SITE DEVELOPMENT PLANS

33 TOWNHOUSE UNITS

1525 & 1601 & 1603 & 1605 EAST 86TH STREET & 1604 & 1606 EAST 87TH STREET
BLOOMINGTON, MINNESOTA

REVISIONS	
04.28.26	CITY COMMENTS
05.12.26	REVISIONS
06.01.26	PLANS FINALIZED

PROJECT: 91040
 SHEET NO. C6 of C16
 SITE PLAN - NORTH

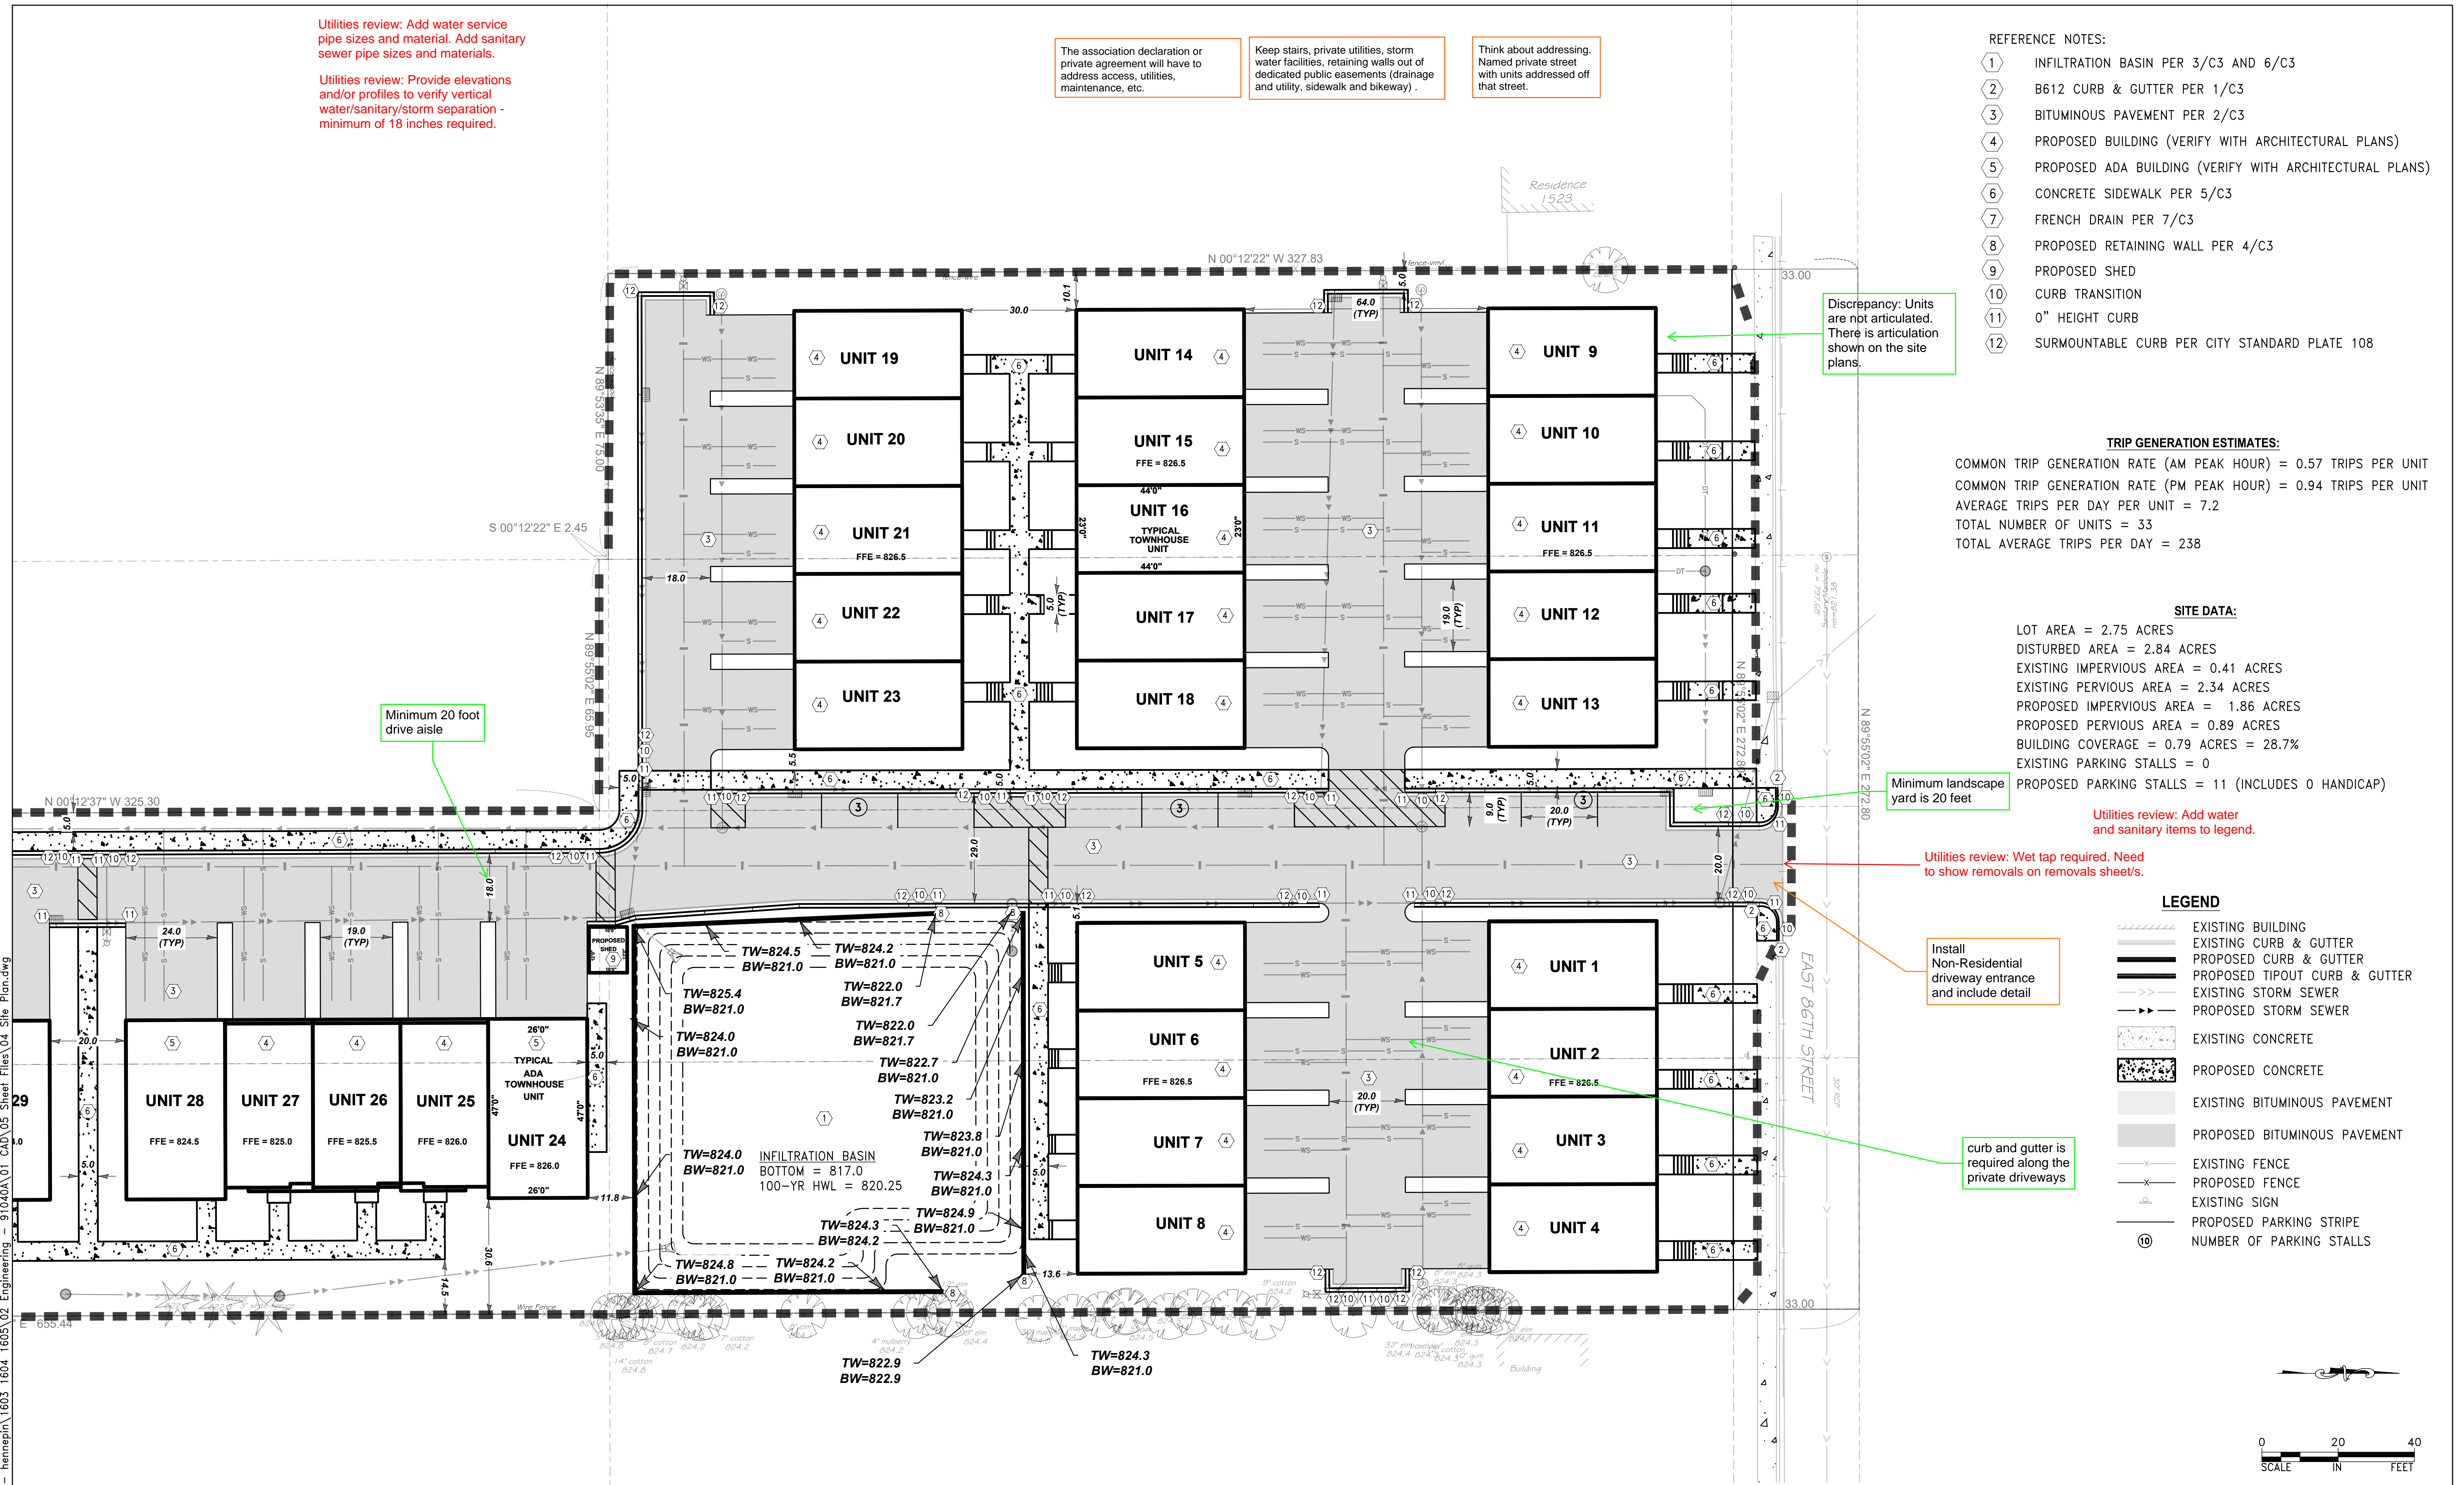
Utilities review: Add water service pipe sizes and material. Add sanitary sewer pipe sizes and materials.

Utilities review: Provide elevations and/or profiles to verify vertical water/sanitary/storm separation - minimum of 18 inches required.

The association declaration or private agreement will have to address access, utilities, maintenance, etc.

Keep stairs, private utilities, storm water facilities, retaining walls out of dedicated public easements (drainage and utility, sidewalk and bikeway).

Think about addressing. Named private street with units addressed off that street.

Utilities review: Add water and sanitary items to legend.

Utilities review: Wet tap required. Need to show removals on removals sheet/s.

Install Non-Residential driveway entrance and include detail

curb and gutter is required along the private driveways

Minimum 20 foot drive aisle

Minimum landscape yard is 20 feet
